Submission of Further Information (FI)

Proposed Temporary Warehouse (excluding Dangerous Goods Godown) with Ancillary Office and Associated Filling of Land for a Period of 3 Years in "Agriculture" Zone, Lots 479 and 480 in D.D. 90, Lin Ma Hang Road, Ta Kwu Ling (Application No. A/NE-MKT/66)

Further Information for Planning Application No. A/NE-MKT/66**Response-to-Comments****Comments from Commissioner for Transport**

**Plan 3a
(P 26019)**

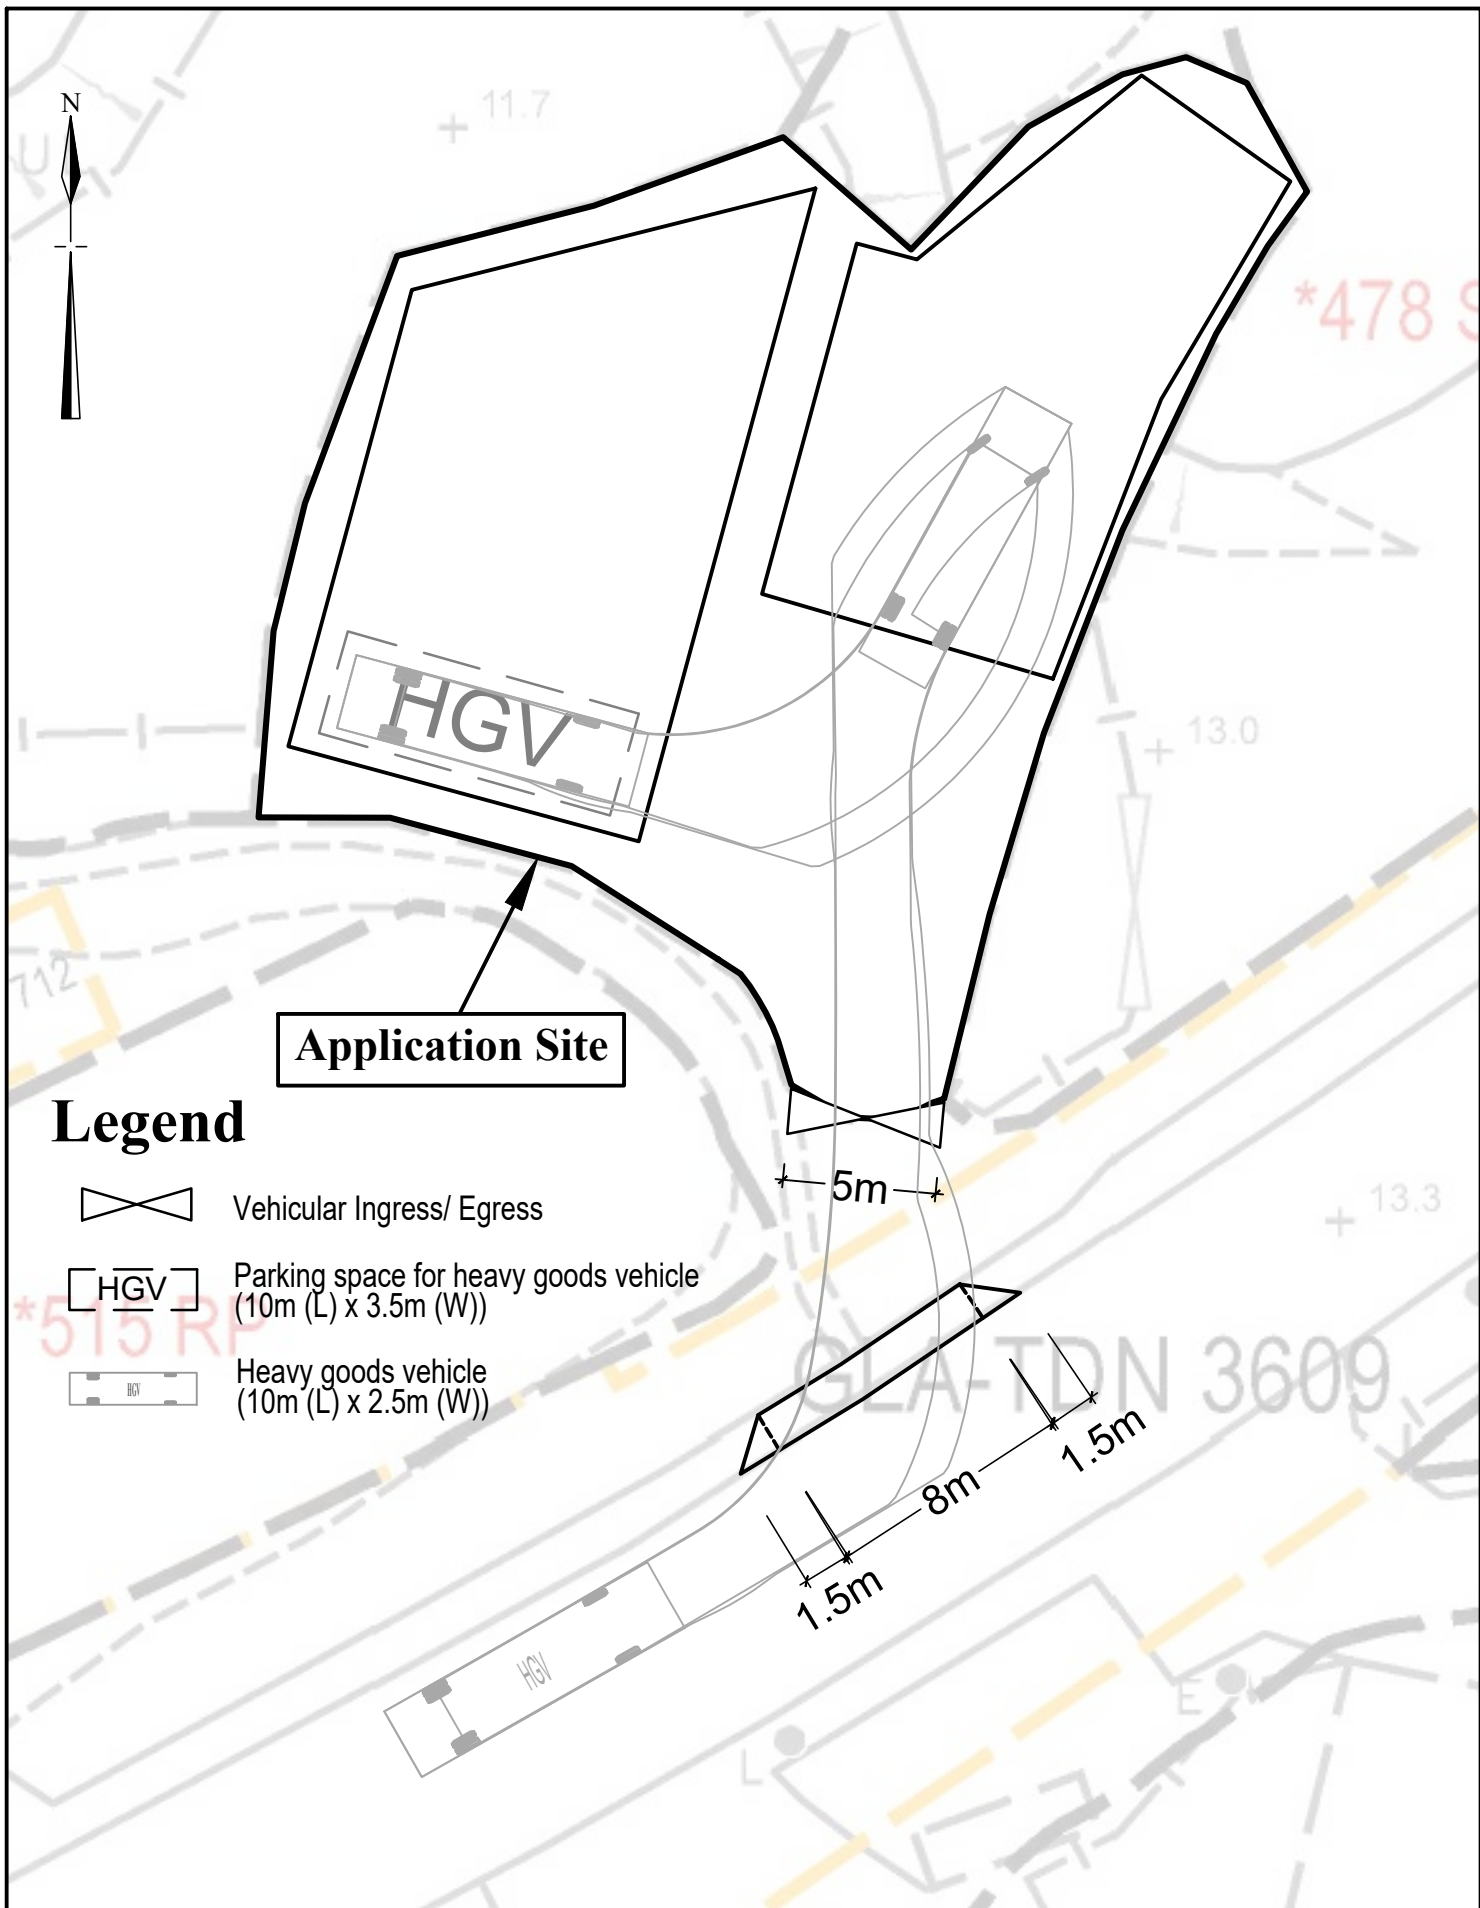
I.	Comments	Responses
1.	The dimension of heavy goods vehicle should be 11m x 2.5m. The applicant should review and revise it;	We would like to clarify that heavy goods vehicles of 10m x 2.5m would be used for the site. Please refer to the revised layout plan (Plan 3a) and swept path analysis (Plan 4a).

1:250	Plan Showing Proposed Run-in / out (Vehicle In)	Goldrich Planners & Surveyors Ltd.
July 2026		Plan 6.1 (P 26019)

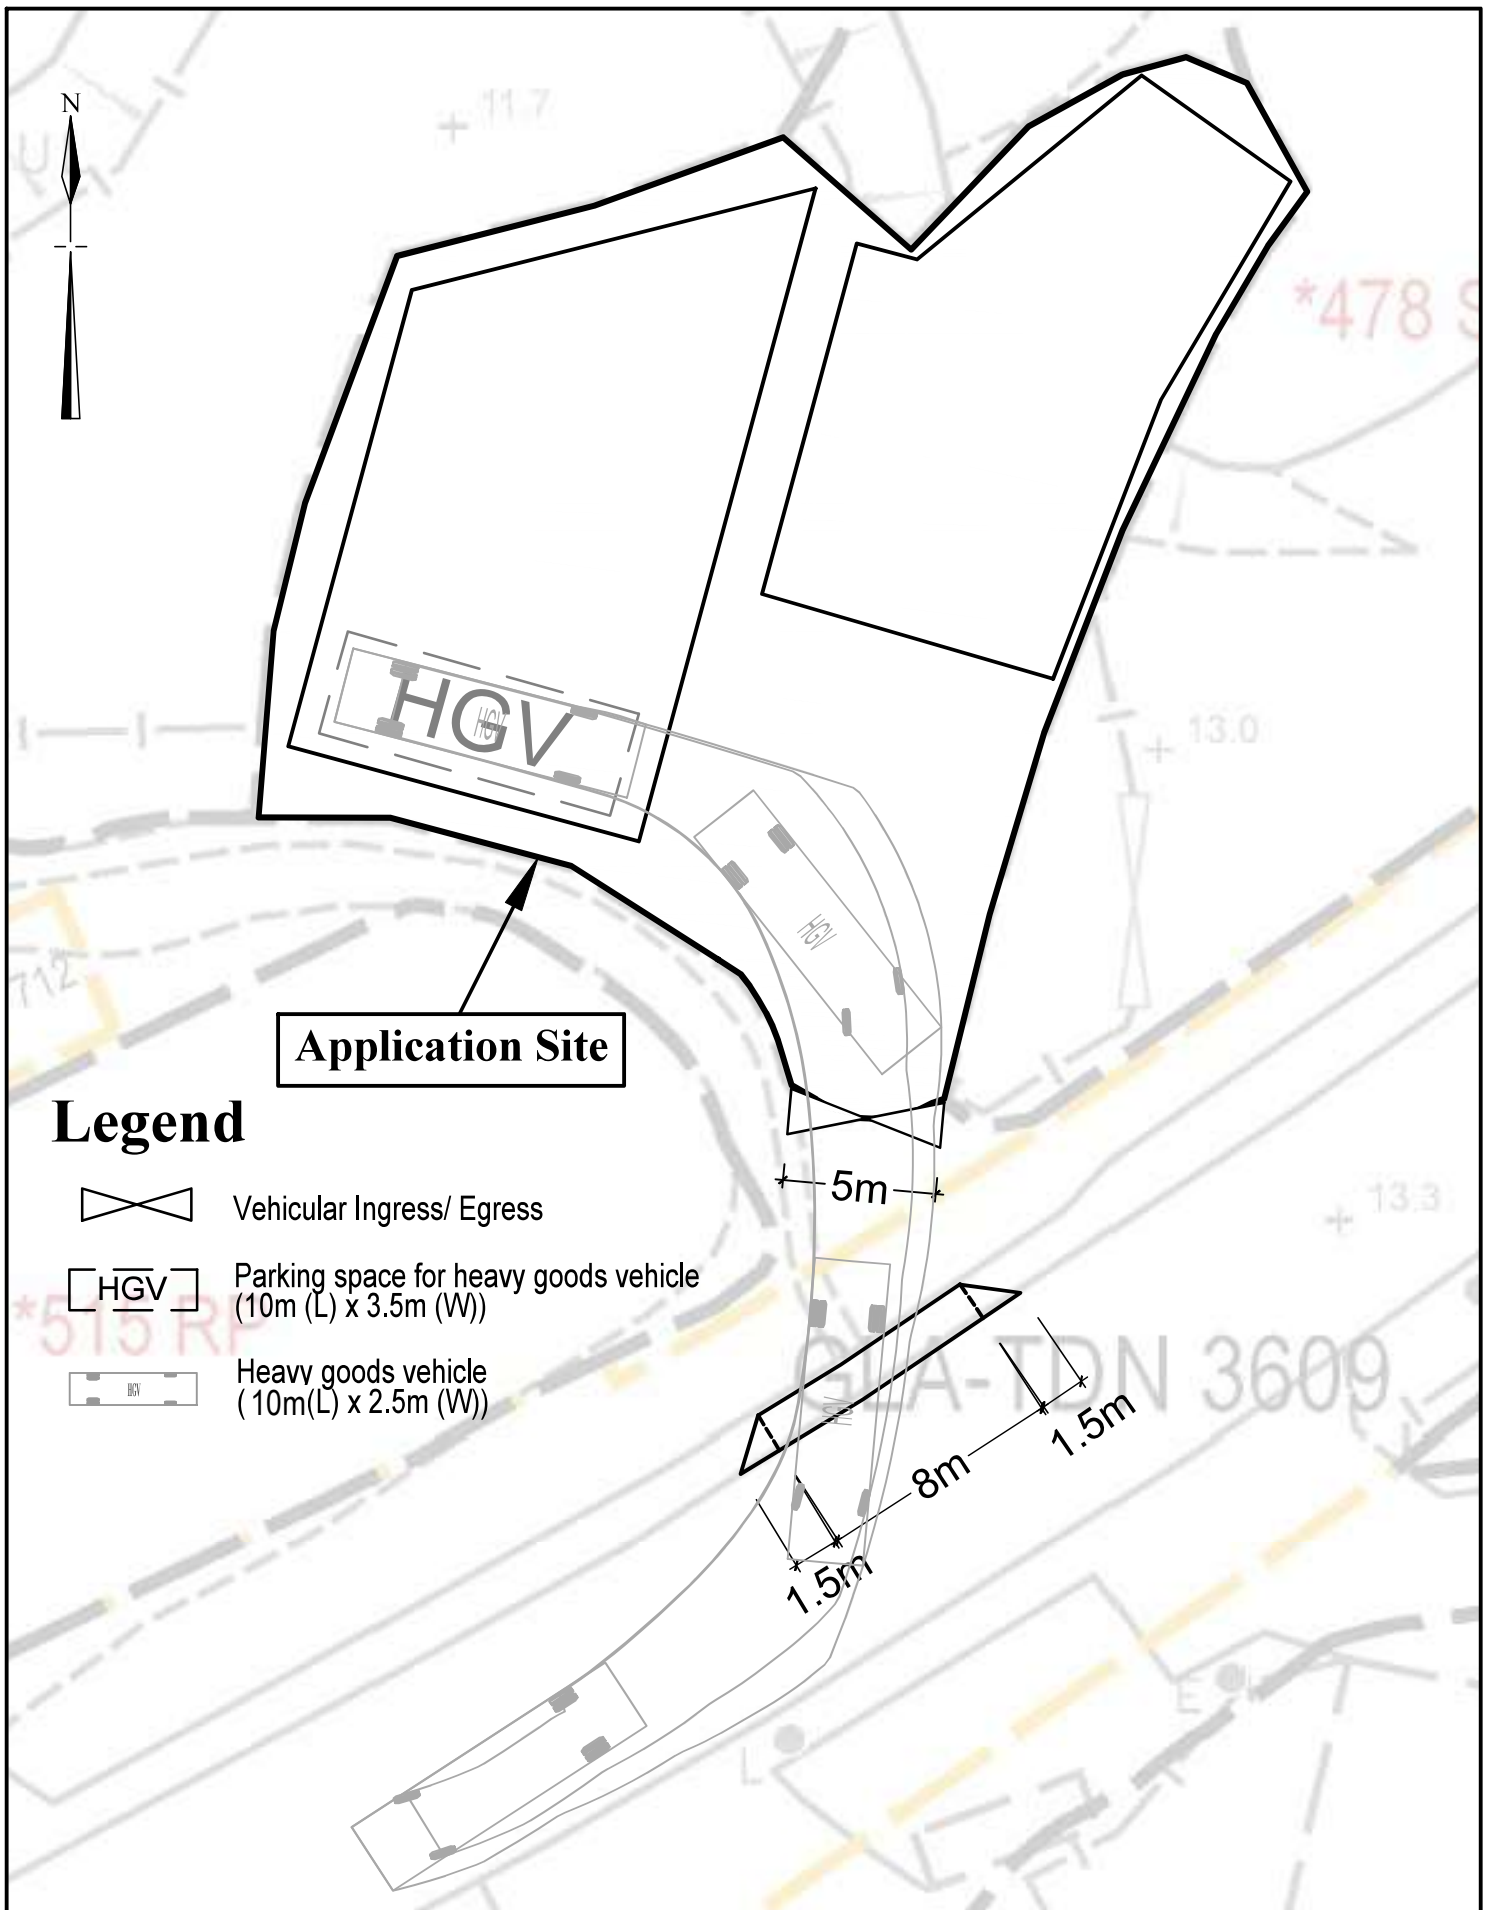
2.	The applicant shall advise the width of the ingress and egress points;	The width of the ingress and egress points is about 5m. Please refer to the proposed run-in/out (Plans 6.1 & 6.2) for details.

3.	The applicant shall provide a proposal on the vehicular access arrangement including the run-in/out design for the vehicles leaving/entering the application site;	Please refer to the proposed run-in/out (Plans 6.1 & 6.2) and HyD's standard drawings (i.e. H5133, H5134 and H5135) for details.
